4801 PROSPERITY CHURCH RD

Mecklenburg County
Health Department

Re: 4801 Prosperity Church Road
File: 712
Parcel: 027-551-98

APPLICATION FOR IMPROVEMENT PERMIT FOR RESIDENTIAL SITE INDIVIDUAL WATER AND WASTEWATER SYSTEMS PROGRAM

PLOT OF SYSTEM

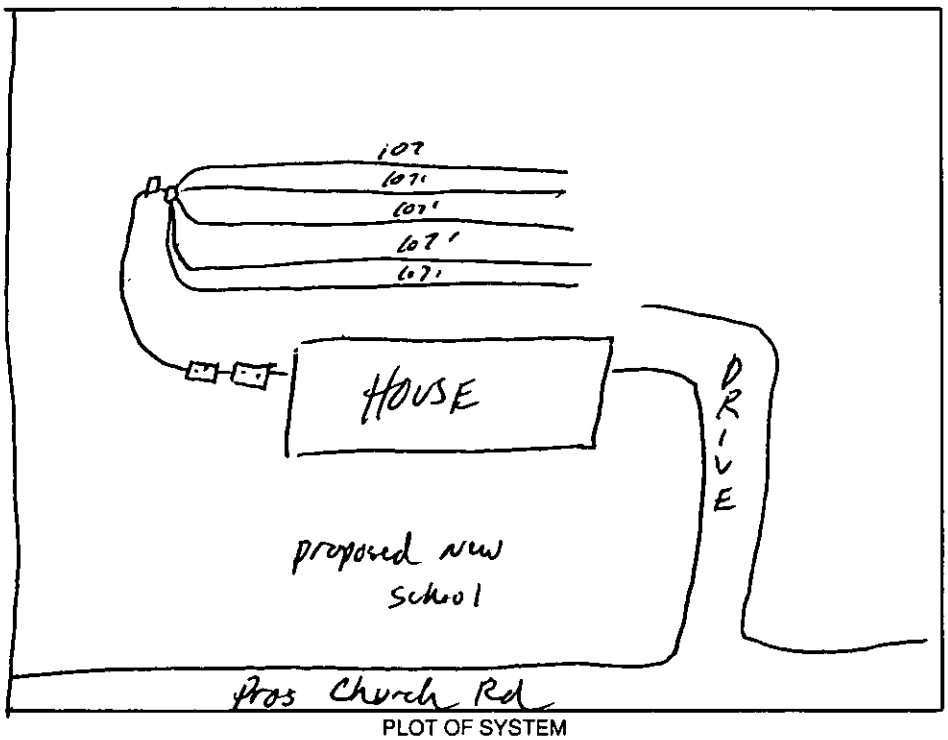
Comments: Alteration, ~~1000 GT~~, PI, 5 lines x 107' long x 3' wd x 12" stone
Keep septic septic system >50' from existing well

PROPOSED PLOT PLAN

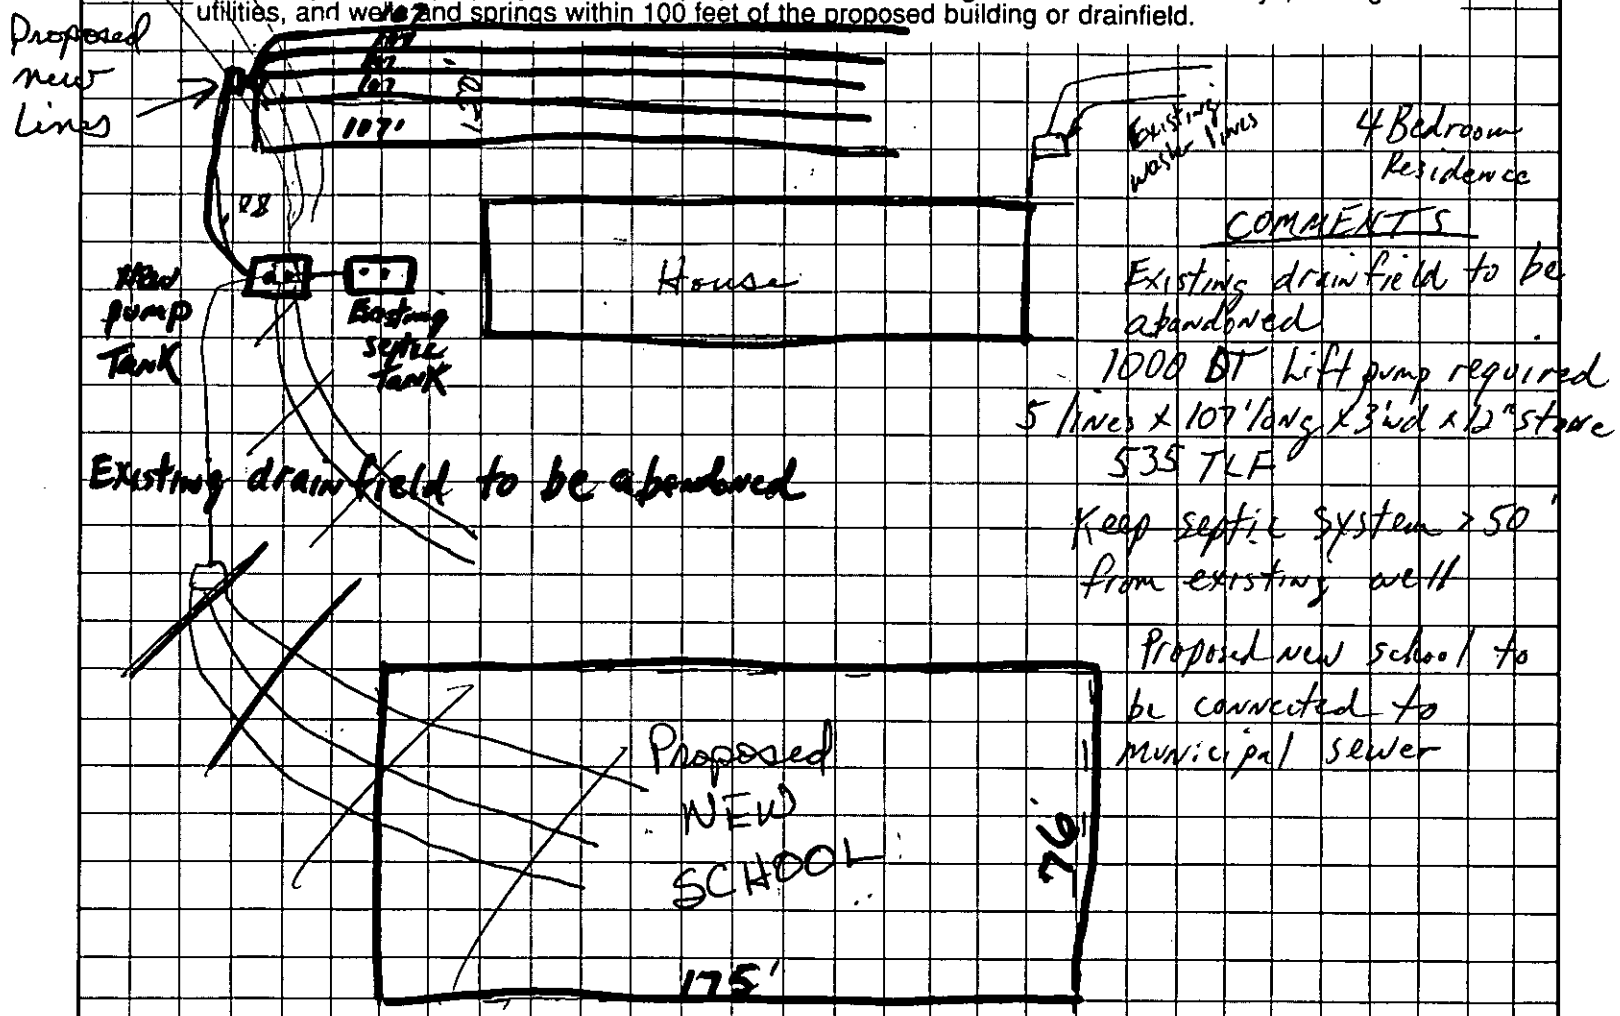
Existing drainfield to be abandoned

1000 GT Lift pump required

5 lines x 107'long x 3'wd x 12"stone

535 TLF

Keep septic system > 50' from existing well

Proposed new school to be connected to municipal sewer

Show profile locations and other site features (dimensions, reference or benchmark, and North).

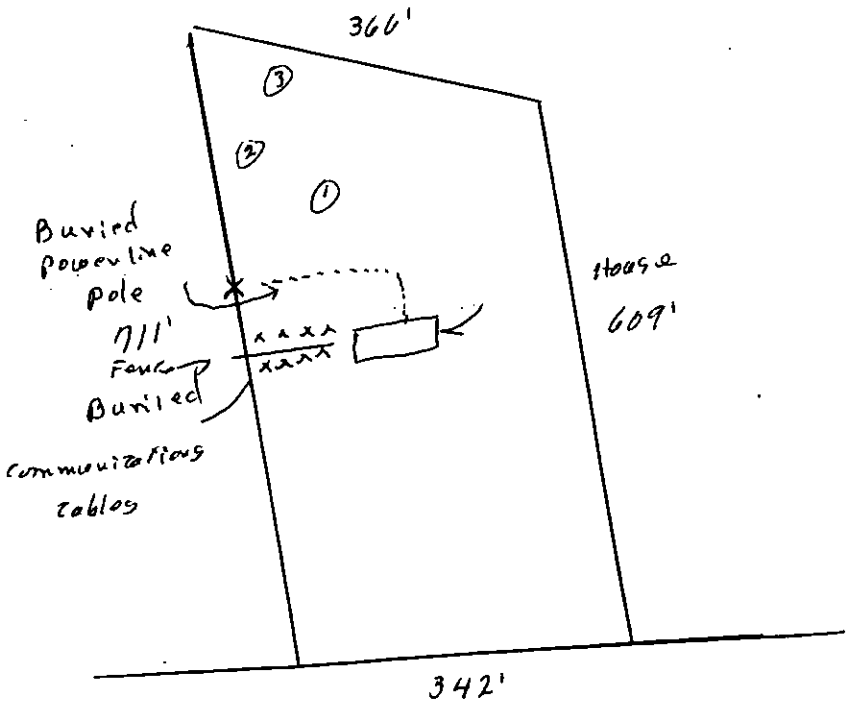
OMMENTS: Would require pump

Show profile locations and other site features (dimensions, reference or benchmark, and North).

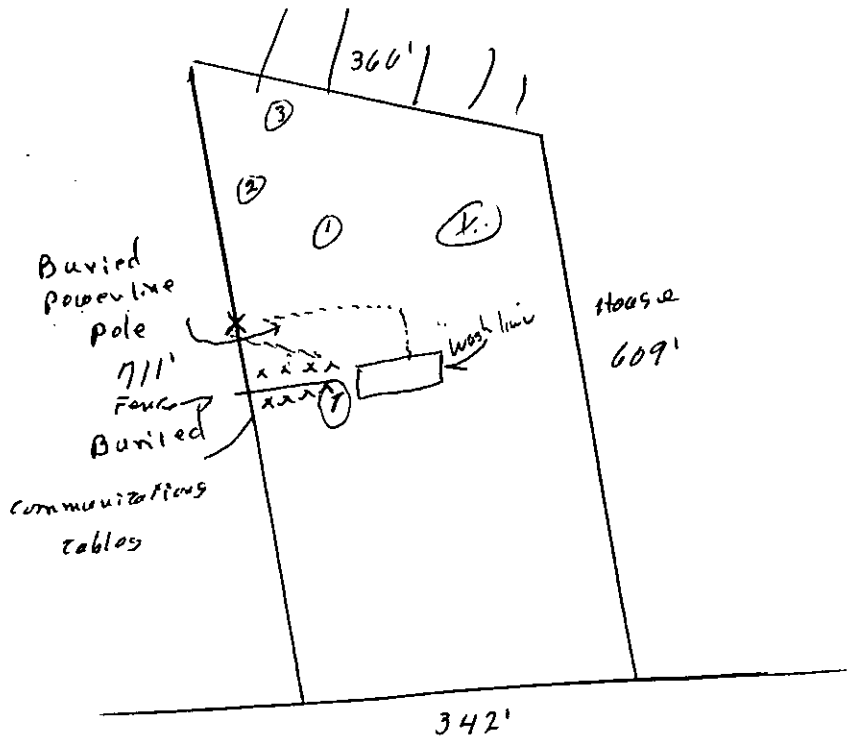
COMMENTS: Would require sewer
